Gad's Hill Place Cupola Repairs.
Notes taken from
meeting @ Fareham Joinery
22/5/2024.
1 of 14 pages.

Project GAD'S HILL SCHOOL, HIGHAM
GAD'S HILL PLACE REPAIRS

Title CUPOLA REPAIRS
EXISTING SECTION AND SIDE ELEVATION

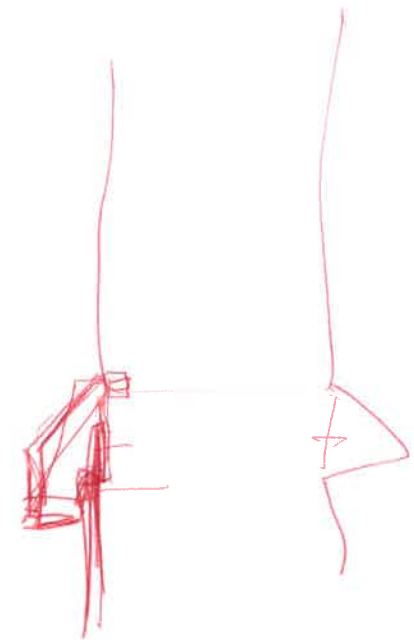
60% of weather vane is lead.
 Gold leaf won't hold.
 Prepare wire brush & repaint w/ gold.
 coloured paint instead

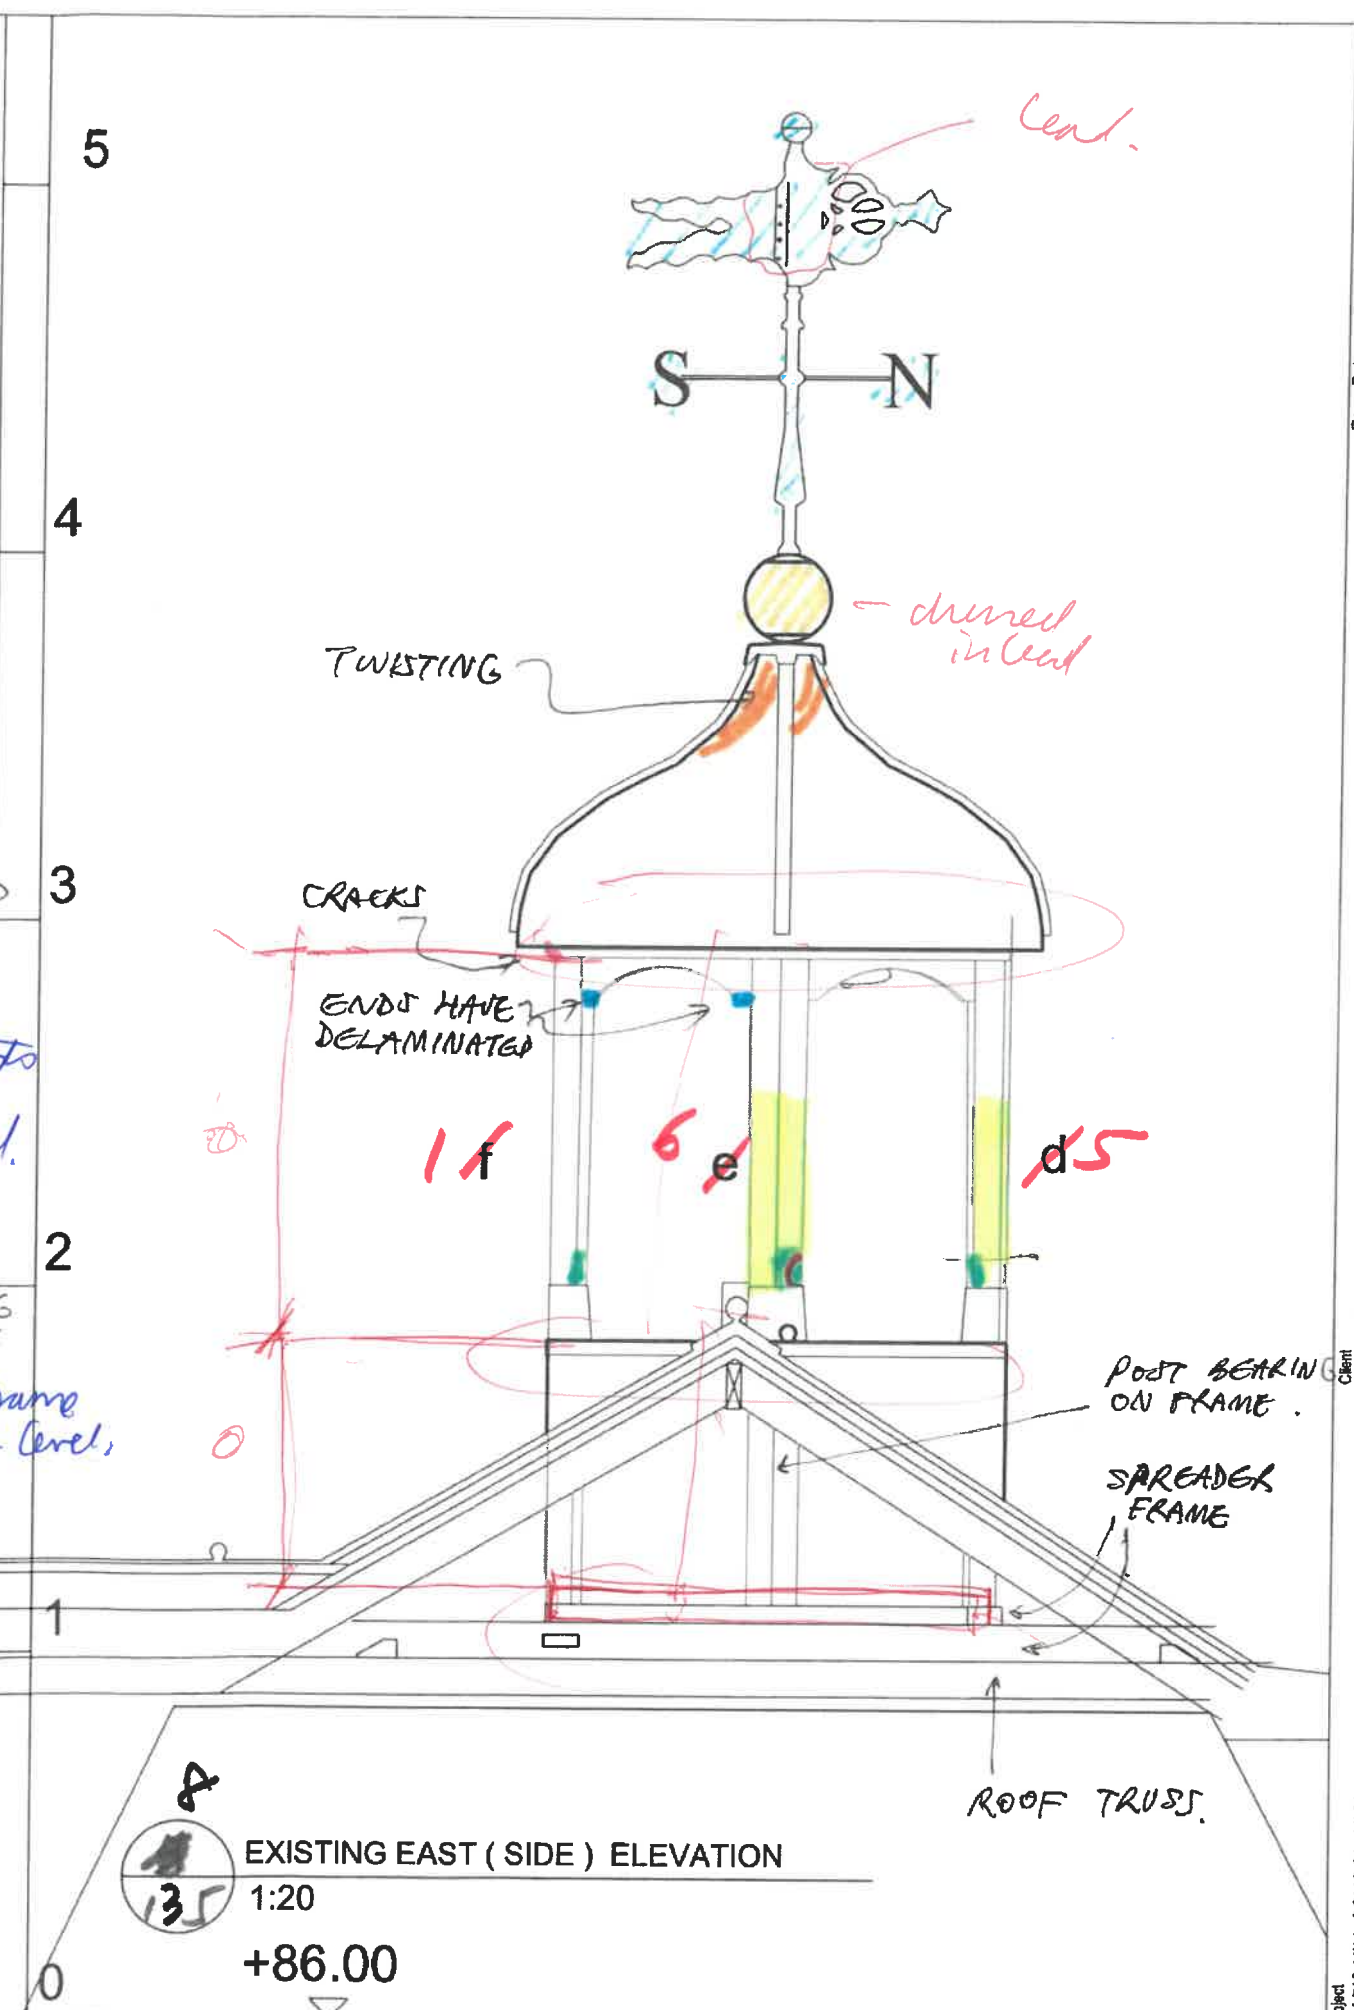
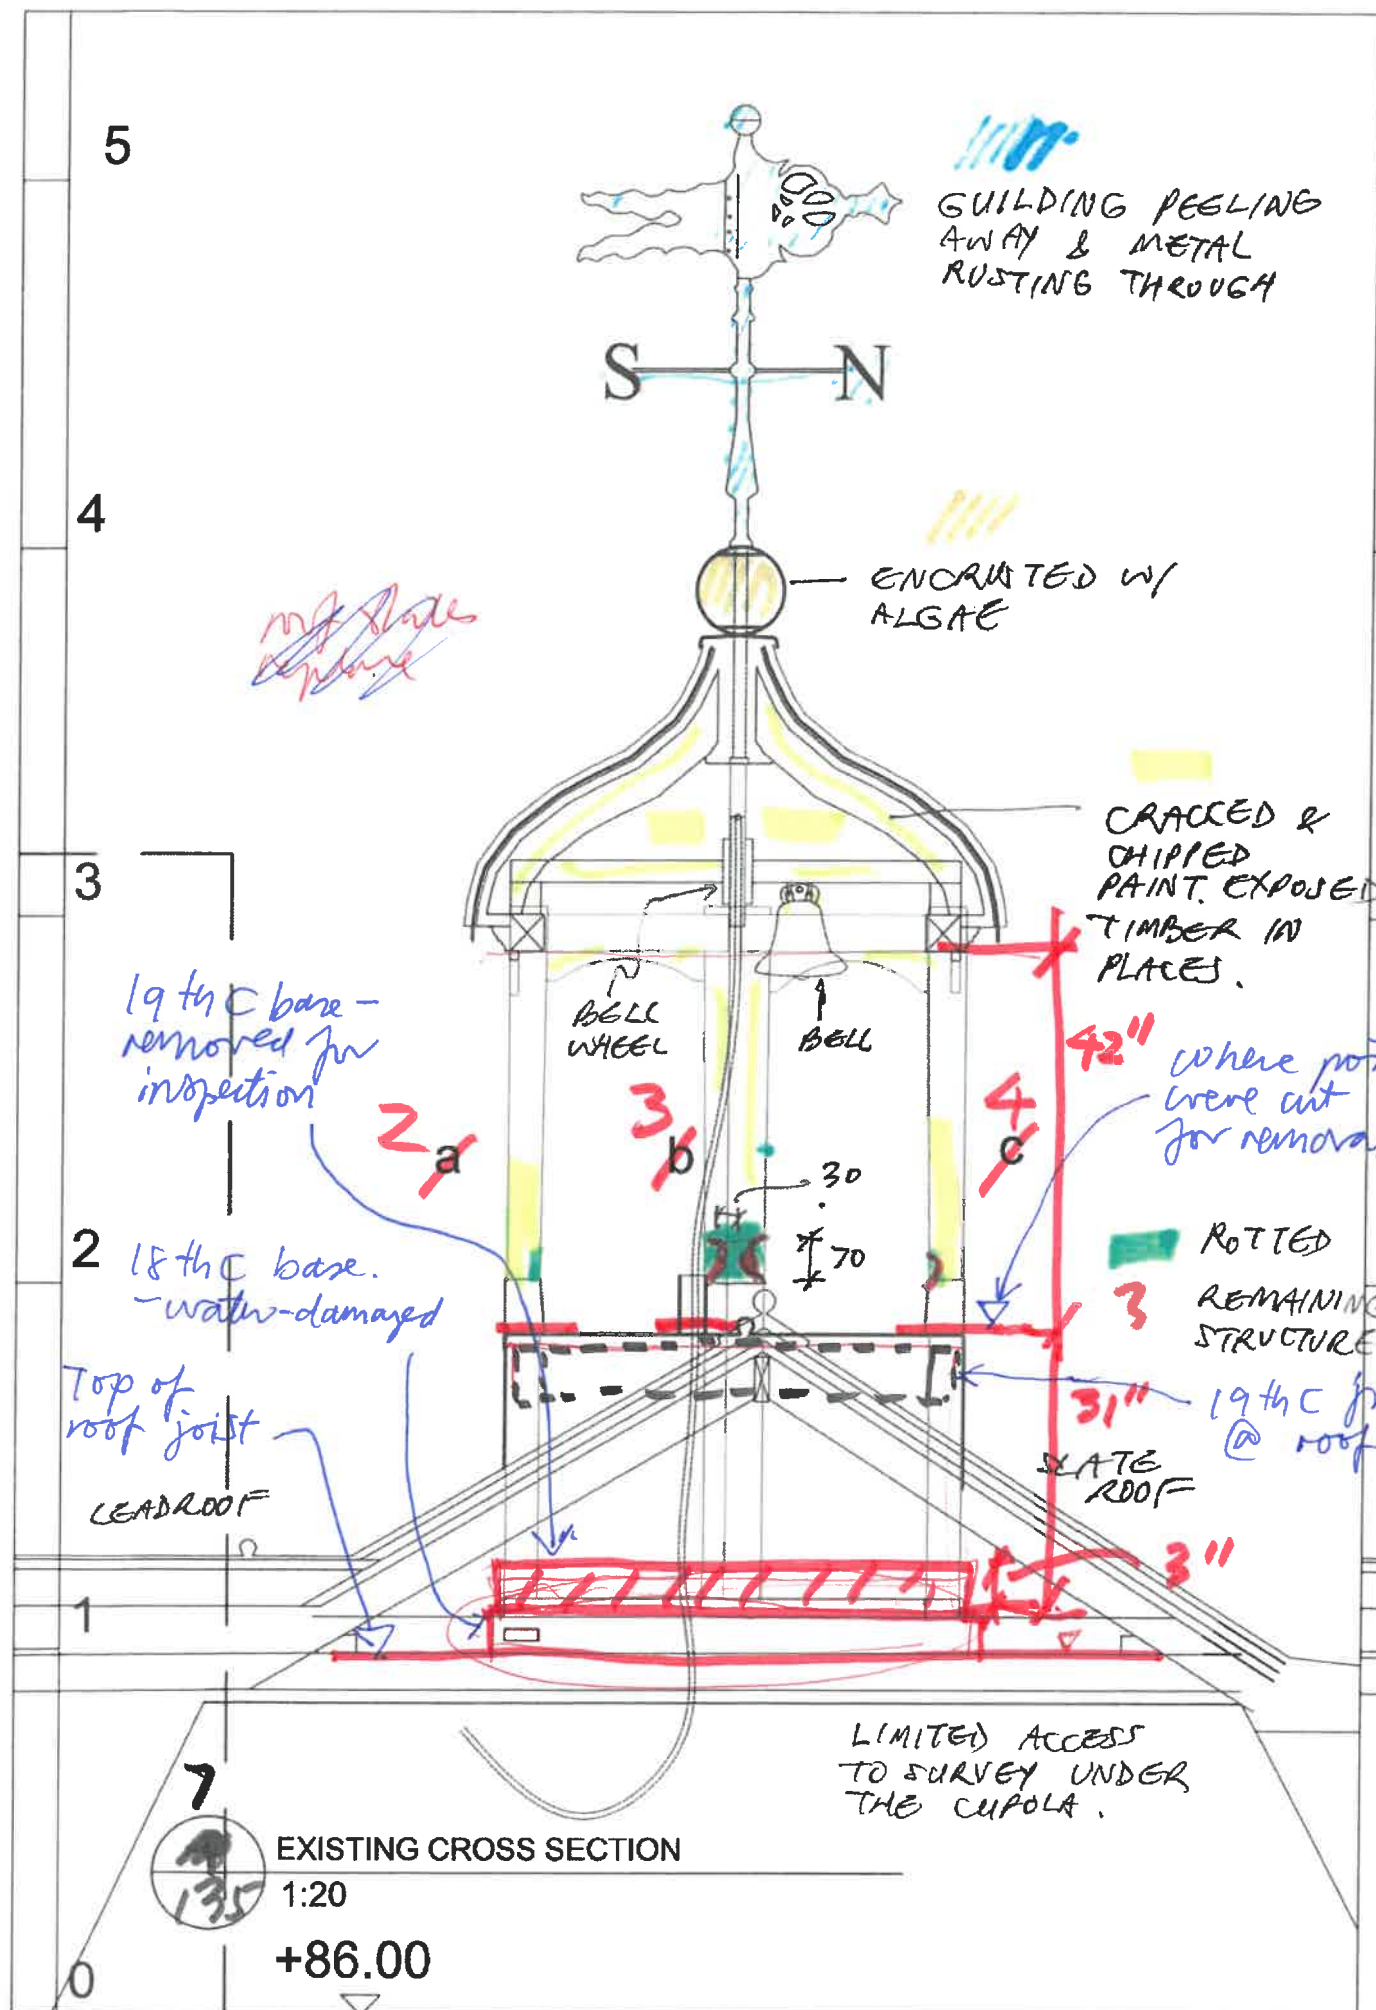
SPLIT.

CRACKED & PEELING PAINT. EXPOSED TIMBER.

ROTTED

REMAINING STRUCTURE

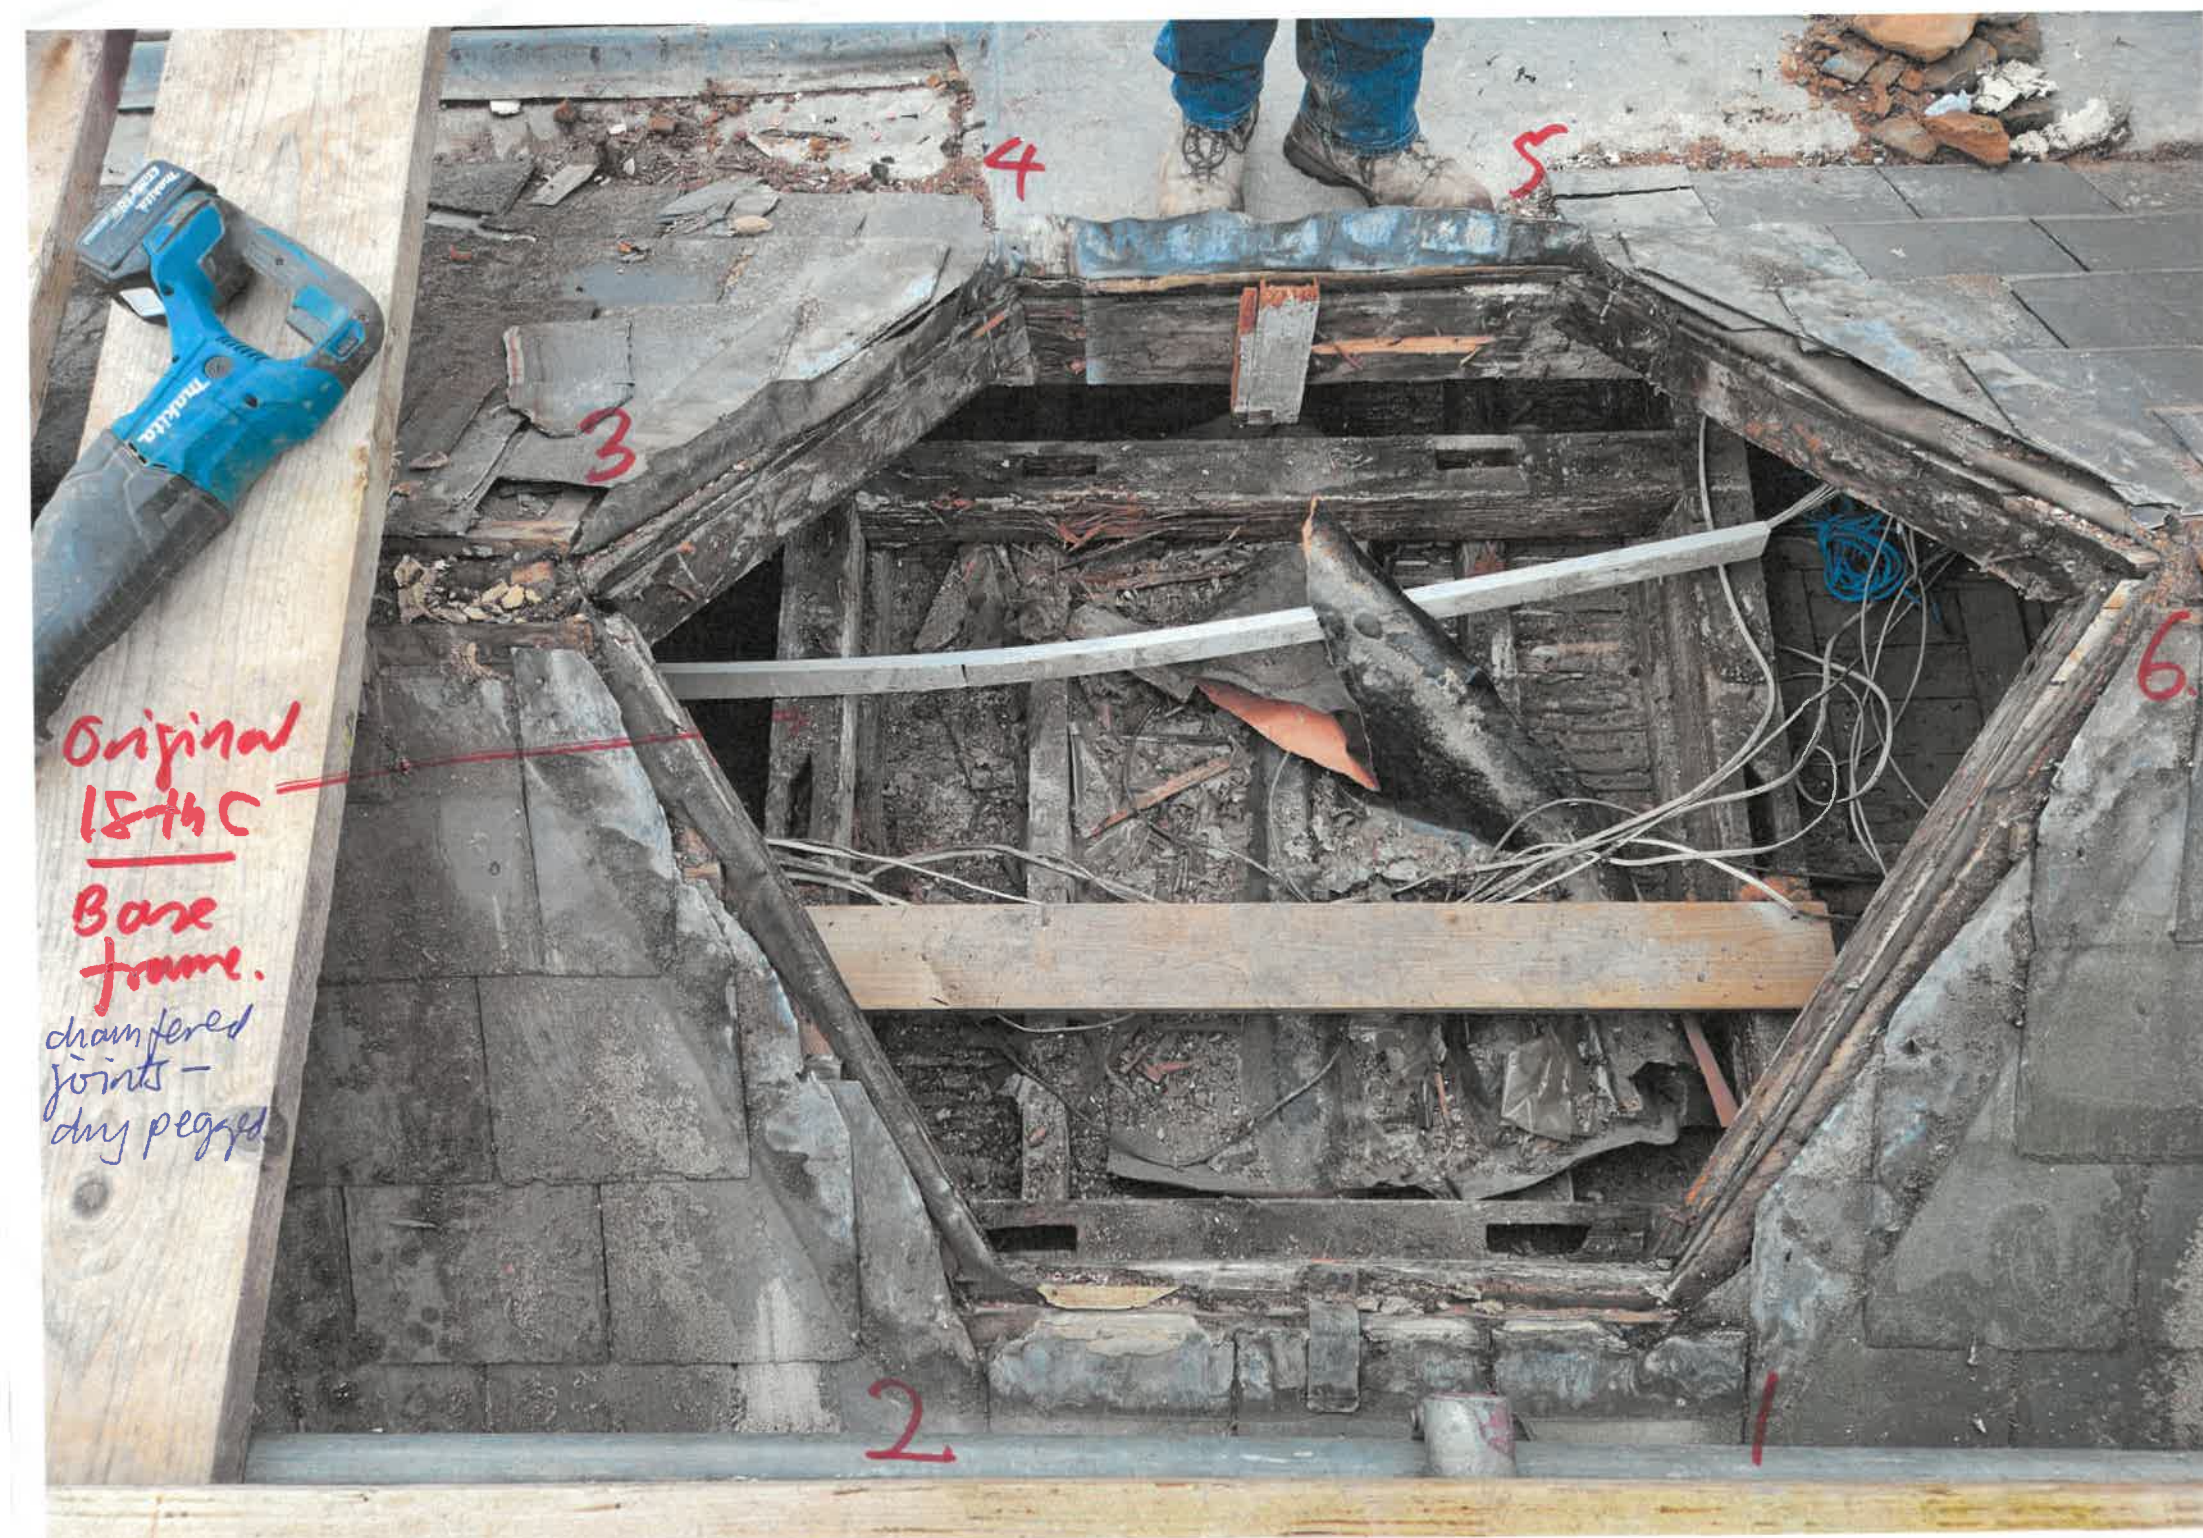
Original
18th C
Base
frame.

chamfered
joints -
dry pegged

Removed
19th C BASE
Sat on top of
THIS

Original 18th C
frame BASE
frame.

Chamfer
tenons
- dry -
puffed.

Historic water
damage

19th base
frame - Toth-pined
tenon joint to post.
